RRIS Technical Support Bulletin # 1048

SUBJECT: Console may experience lockup when CUE audio is played

PRODUCT: RMX*digital* KSU circuit boards, PN 95-2672-(1/2)

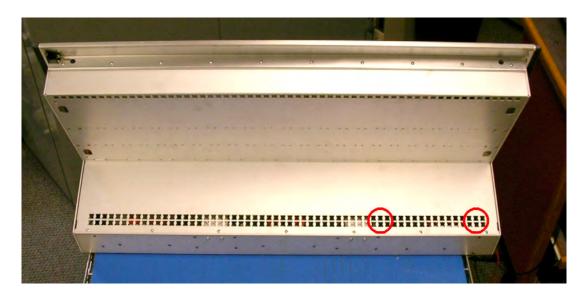
REQUIRED ACTION: Visually inspect the console to determine whether or not capacitor C63 is present on the KSU module. The following image shows the locations of the revision markings (to the left) and capacitor C63 (to the right) on the KSU module:

The KSU module is installed in the right-most slot under the console's hinged top cover. The revision markings and the location of capacitor C63 can be viewed through the ventilation holes in the console's lower-front cover, which is below countertop level. The following picture shows the areas through which the revision markings (leftmost circle) and C63 (rightmost circle) can be viewed. A small flashlight is usually required to see clearly in this area:

If a KSU module is found on which C63 is present, the capacitor must be removed from the board. This may be accomplished by using two conventional soldering irons in a tweezers-like fashion to simultaneously melt the solder on both sides of the component, and then lift it up off of the circuit board. No other modifications are necessary. In order to service the KSU module, the power to the console must be shut off, and the KSU module removed from the top of the console by unscrewing and then pulling up on the two or four knurled thumbsrews which secure the module to the console.
